## Marion Stone Appeal

### Excerpts from the Department's License Record

- Memos and Review Comments from Maine Geological Survey
  - June 28, 2008
  - February 25, 2009
  - September 2, 2009

**Stone Property, 14 Harmon Street, Scarborough, ME, Permit#L-24089-4H-A-N**  
**Kohlberg Property, 10 Smithers Way, Scarborough, ME Permit#L-24088-4H-A-N**

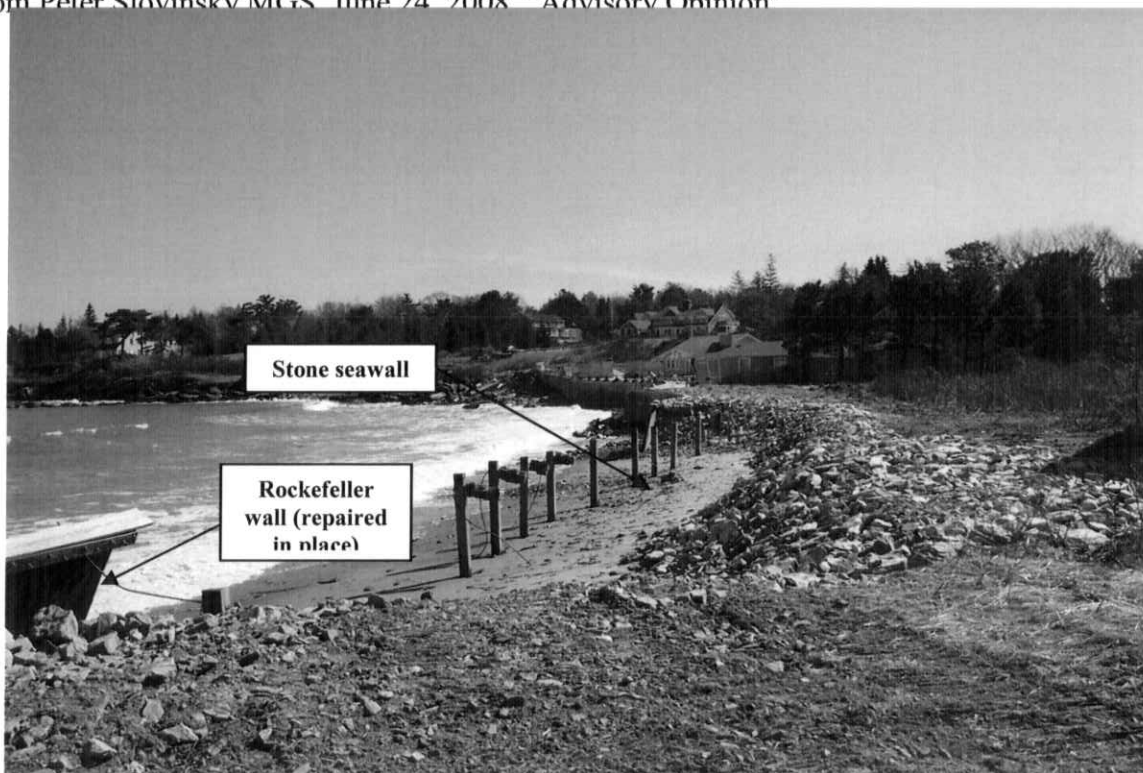
A section of an existing timber bulkhead seawall along the Stone property, at the bulge noted in Figures 1 and 2, was damaged in the 2007 Patriots' Day storm. Damage along the seawall, including a portion of the wall owned by the property owner to the north, was documented by MGS on April 20, 2007 (Figure 3). Although the entire stretch of residential development along this portion of Scarborough Beach was extensively overwashed during the storm, this is the only section of seawall that failed, along with a small adjoining section of a neighboring wall to the north (Rockefeller property). Sediment was released to the beach during the failure in a manner similar to frontal dune erosion in a natural setting. The bulkhead section of the Rockefeller property was repaired under a Permit-By-Rule to pre-existing conditions, dune sand replaced, and dune grass was planted. The section of wall that was damaged previously bowed seaward along a portion of its stretch (see Figure 2). The entire seawalled stretch of this section of the beach was extensively overtopped, with overwash deposits penetrating over 150 feet into the dune (Figure 4).

At the Stone property, we also recommend that any seawall design, whether it be a sloped wall or vertical structure, effectively *remove the bulge in the shoreline that was present prior to the Patriots' Day storm*. The new wall should begin at a location that ties in with the adjacent shoreline, thereby removing the erosion-prone bulge. This would likely help the natural migration of cobble down the beach and formation of the natural cobble apron adjacent to the seawall. This cobble apron aids in dissipating wave energy before it reaches the seawall.
